Ref. No. MCHI/PRES/24-25/140

**Sub:** Installation of IOT in the residential buildings as per BMC Fire department circular no 66 dated 14.10.2022 based on Government of Maharashtra GR no 2021/114/Urja 5 Dated 27.08.2021. --- Monopoly of one vendor.

**SUB: MINUTES OF MEETING ON PEATA / MCHI REPRESENTATION**

**Brigade Routine Circular No. 12 dated 07.06.2024**

FIRE TOWER SKETCH - FOR BUILDING HEIGHT ABOVE 70MT

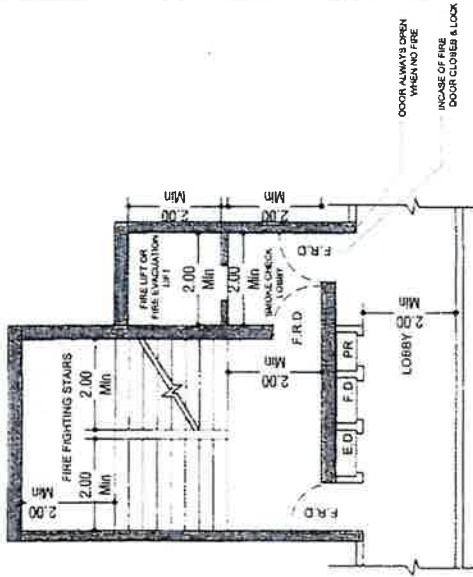
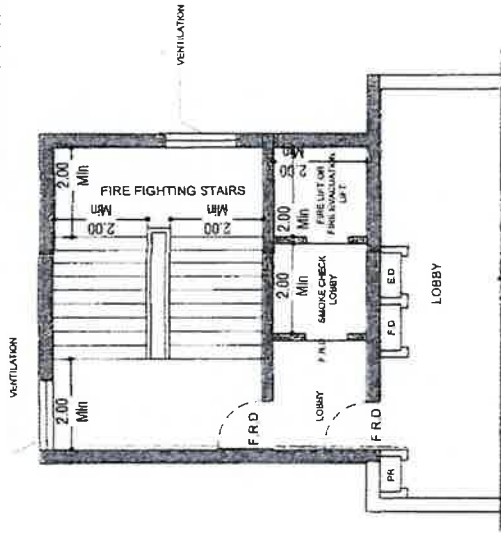
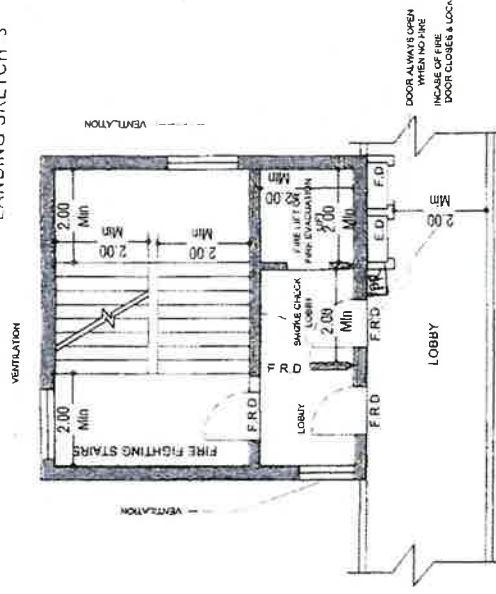
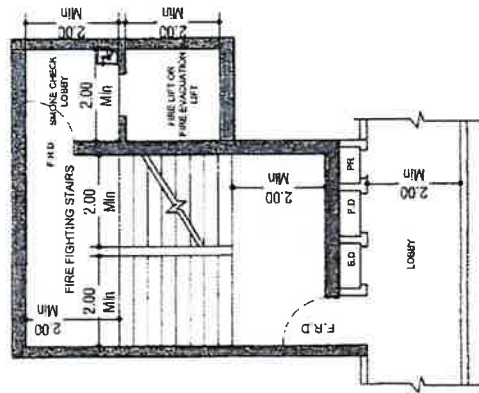
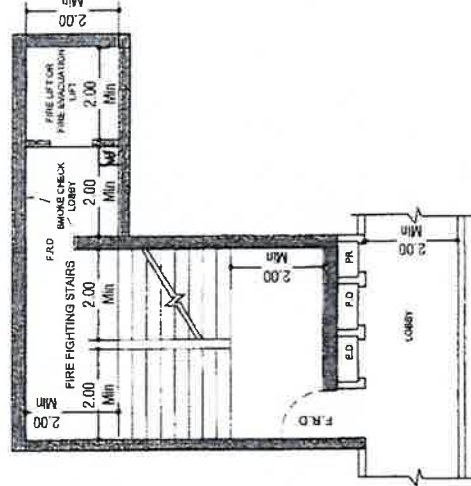
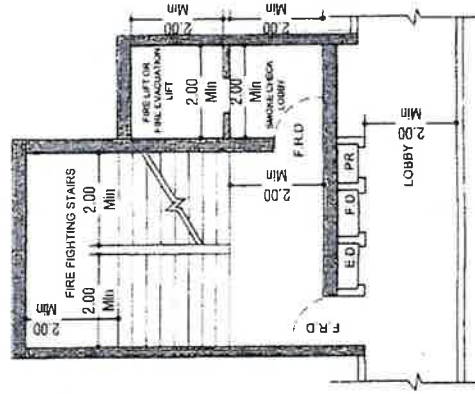
array of the sprinkler and façade should not be more than 600 mm centre to centre Distance for such sprinklers should not be less than 3.5 m (Sketch enclosed)
<b>E Fire Tower &amp; External Fire Evacuation System</b>			
12	Provision of Fire Tower & External Fire Evacuation System as Reg. 48 (9)(B) of DCPR 2034	<p>As per DCPR Regulation 48 (9) (B) two type of systems any one of which provided shall be Agreed.</p> <p>Provision of Regulation reads as below:</p> <p><i>"For High Rise Building having height more than 70m shall be provided with <u>Fire tower</u> at Landing / Mid-landing Level with Smoke Check Lobby with Firemen's Lift being integral part of the Fire Escape Staircase <u>or</u> <u>Fire Evacuation Lift</u> (Hydropneumatics' / electrically operated) on external face of the building having opening within the fire escape staircase at landing / mid-landing level with smoke check lobby as approved by CFO shall be provided.</i></p> <p><u>Fire Tower</u> if proposed shall be as per General arrangement of Fire Tower as per NBC and/or as per report of the expert Committee regarding Special Safety Regulations formulated by High Court in respect of Man made disasters.</p> <p><u>Fire Evacuation lift</u> if proposed shall be as per General arrangement and shall be as per sketches approved by CFO</p>	<p>Agreed as per sketch enclosed.</p> <p>Fire Evacuation lift of min. load capacity of 1000 kg (for fresh proposals) if proposed shall be generally as per General arrangement and it shall be as per sketches enclosed so that double redundancy for the fire evacuation lift is achieved.</p>

Issue Raised	Discussion	Action
	<p>Provision of Regulation reads as below:</p> <p><i>"For High Rise Building having height more than 70m shall be provided with <b>Fire tower</b> at Landing / Mid-landing Level with Smoke Check Lobby with Firemen's Lift being integral part of the Fire Escape Staircase or <b>Fire Evacuation Lift</b> (Hydropneumatics' / electrically operated) on external face of the building having opening within the fire escape staircase at landing / mid-landing level with smoke check lobby as approved by CFO shall be provided.</i></p> <p><b>Fire Tower</b> if proposed shall be as per General arrangement of Fire Tower as per NBC and/or as per report of the expert Committee regarding Special Safety Regulations formulated by High Court in respect of Manmade disasters.</p> <p><b>Fire Evacuation lift</b> if proposed shall be as per General arrangement and shall be as per sketches approved by CFO</p>	<p>Tower as per NBC and/or as per report of the expert Committee regarding Special Safety Regulations formulated by Hon'ble High Court in respect of Man-made disasters.</p> <p>Fire Evacuation lift if proposed shall be as per General arrangement and it shall be as per sketches (as published in the DCPR-2034) approved by CFO</p>
